KANSAS GAS AND ELECTRIC COMPANY

KMLNRC 84-211  
Re: Doclet No. STN 50-482  
Ref: Letter dated 11/07/84 from DGEisenhut, NRC,  
to GLKoester, KG&E  
Subj: Technical Specifications

The Reference provided the "final draft" of the Wolf Creek Technical Specifications for KG&E review and affirmation.

TECHNICAL SPECIFICATION CHANGES

FIGURE 6.2-1  
OFFSITE ORGANIZATION

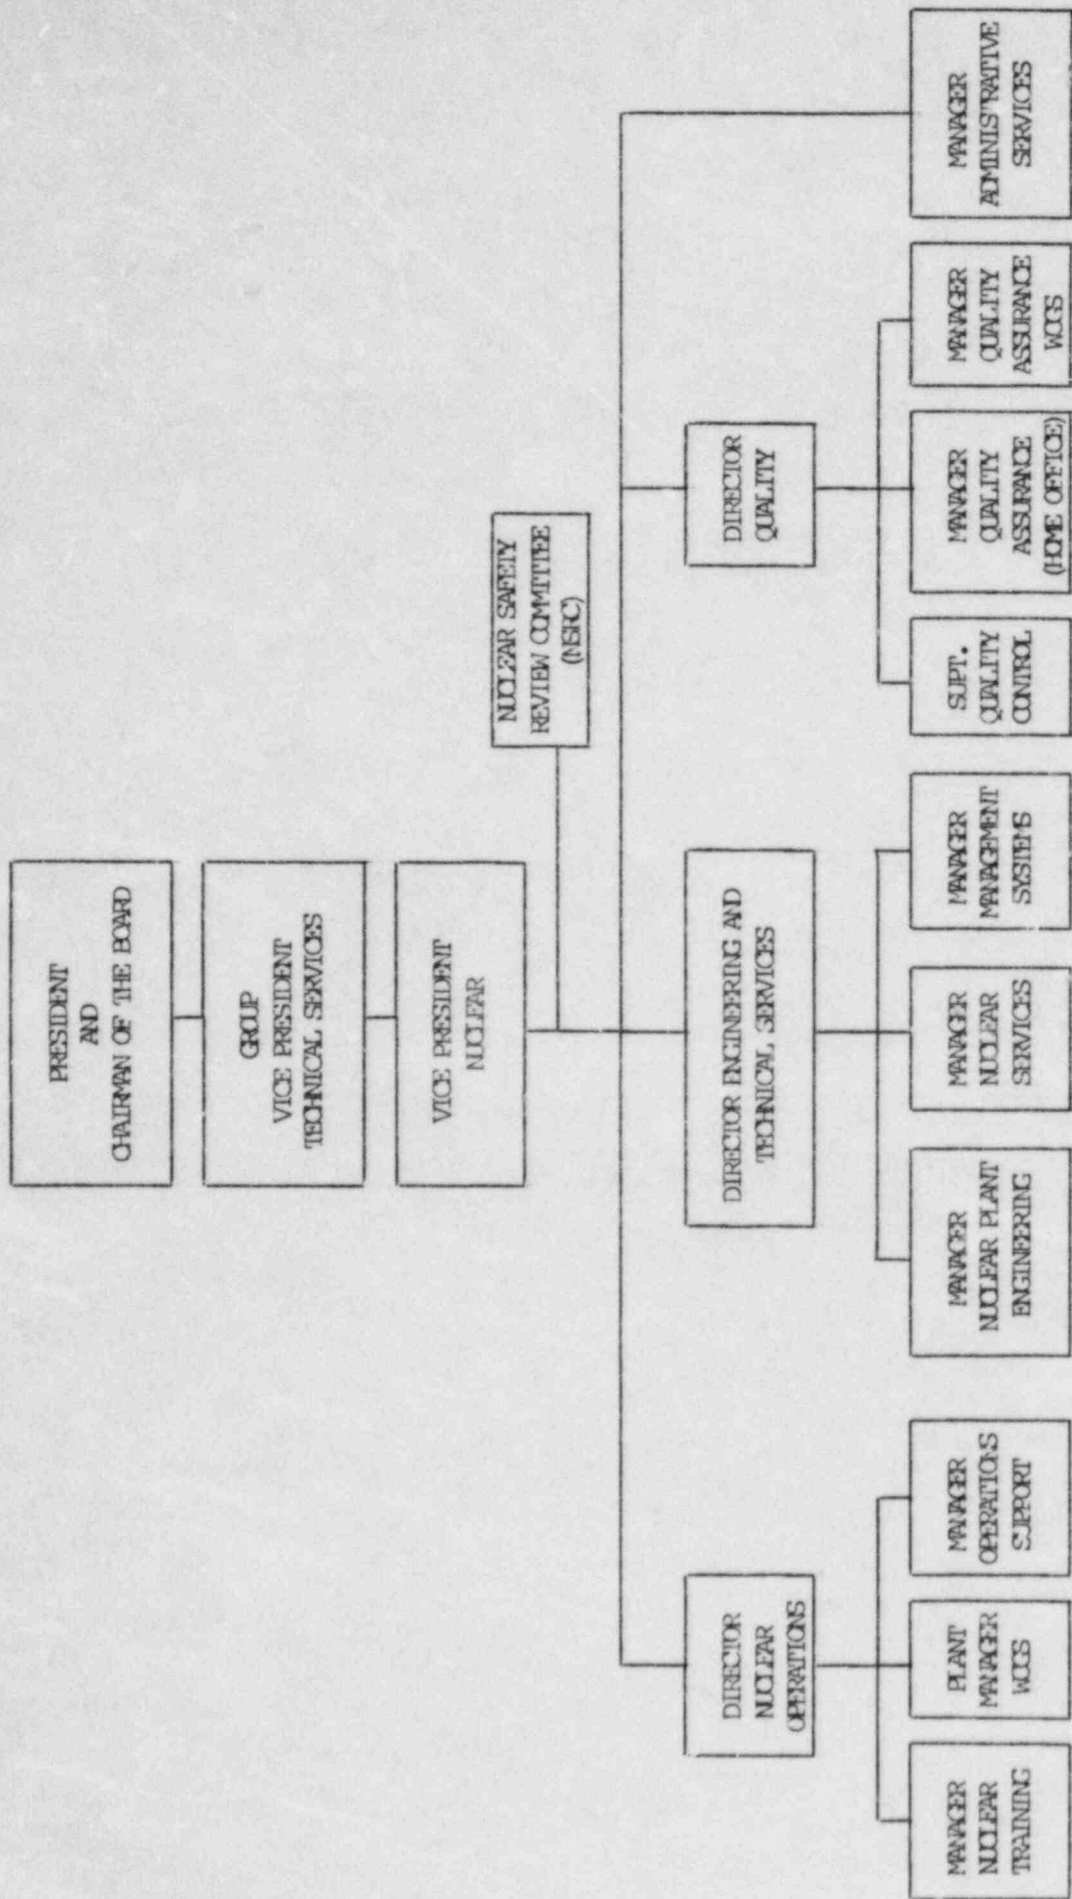
Page	Section	Reason for Change
B 3/4 3-4	3/4.3.3.5	Consistent with design and rest of Tech Spec.
B 3/4 3-5	3/4.3.3.10	Typo.
B 3/4 3-6	3/4.3.3.11	Typo.
B 3/4 4-9	3/4.4.9	Typo.
B 3/4 6-1	3/4.6.1.2	Revised to be consistent with 10CFR50, Appendix J.
B 3/4 6-2	3/4.6.1.6	R.G. 1.35 is not a proposed R.G.
B 3/4 6-3	3/4.6.1.7	Refer to justification for changes to 5.7.
B 3/4 7-6	3/4.7.8	Justification with change in attachment.
B 3/4 8-2	3/4.8.1, 3/4.8.2 & 3/4.8.3	Typo.
B 3/4 11-3	3/4 11.2.1	Typos.
5-2	Fig. 5.1-1	Clarification of Figure.
5-9	Table 5.7-1	Typos.
6-3	Fig. 6.2-1	Update organization chart.
6-4	Fig. 6.2-2	Update organization chart.
6-23	6.12.2	Clarification.
